Access Compliance Report

Public Rights-of-Way

Intersection ID: 12701	Main Street: HICKORY GROVE RD	Cross Street: MARKET ST	Location: NW
ADA ID: C08BF182901B	Ramp Type: PerpDiag	Initial Pass/Fail: Fail	Overall Compliance: No
		Severity Score: 35

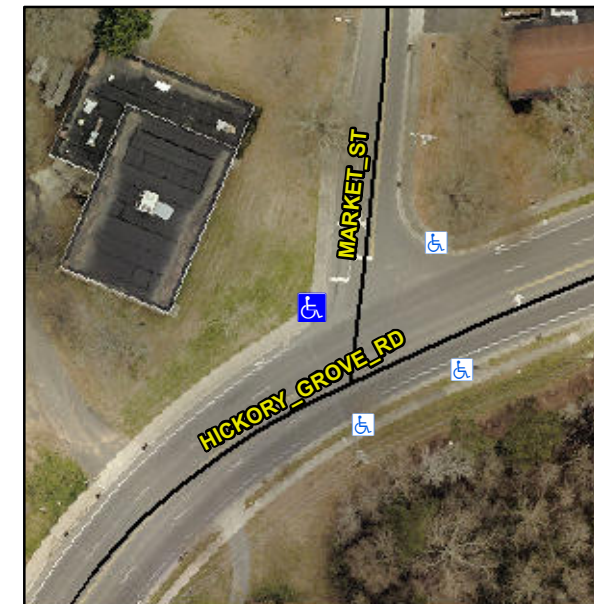
Not Found, R304.5.1, R304.2.2, R304.5.3

Compliance	Description	Data	Compliance	Description	Data
N/A	Ramp Length (in)	25.0	No	Ramp Slope (%)	14.8
No	Ramp Width (in)	41.0	No	Ramp XSlope (%)	2.3
N/A	Flare Type LT	N/A	N/A	Flare Type RT	N/A
N/A	Flare Slope LT (%)	N/A	N/A	Flare Slope RT (%)	N/A
N/A	Flare Traversable LT?	N/A	N/A	Flare Traversable RT?	N/A
N/A	Landing Length (in)	N/A	N/A	DWS Provided?	N/A
N/A	Landing Width (in)	N/A	N/A	DWS Contrast?	N/A
N/A	Landing Slope (%)	N/A	N/A	DWS Length (in)	N/A
N/A	Landing X Slope (%)	N/A	N/A	DWS Full Width?	N/A
N/A	Landing Curb? (Y/N)	N/A	N/A	DWS Offset (in)	N/A
N/A	Shared Landing?	N/A			
N/A	Gutter Ponding?	N/A	N/A	Gutter Slope (%)	N/A
N/A	Gutter Lip Ht (in)	N/A	N/A	Gutter X Slope (%)	N/A
N/A	Painted X Walk1?	No	N/A	Painted X Walk2?	No
	X Walk 1 Direction	To S		X Walk 2 Direction	To NE
N/A	X Walk 1 Width (in)	N/A	N/A	X Walk 2 Width (in)	N/A
	X Walk 1 Slope (%)	0.4		X Walk 2 Slope (%)	0.7
	X Walk 1 X Slope (%)	1.0		X Walk 2 X Slope (%)	2.0

Remove & Replace Curb Ramp With Two New Directional Ramps or Equivalent.
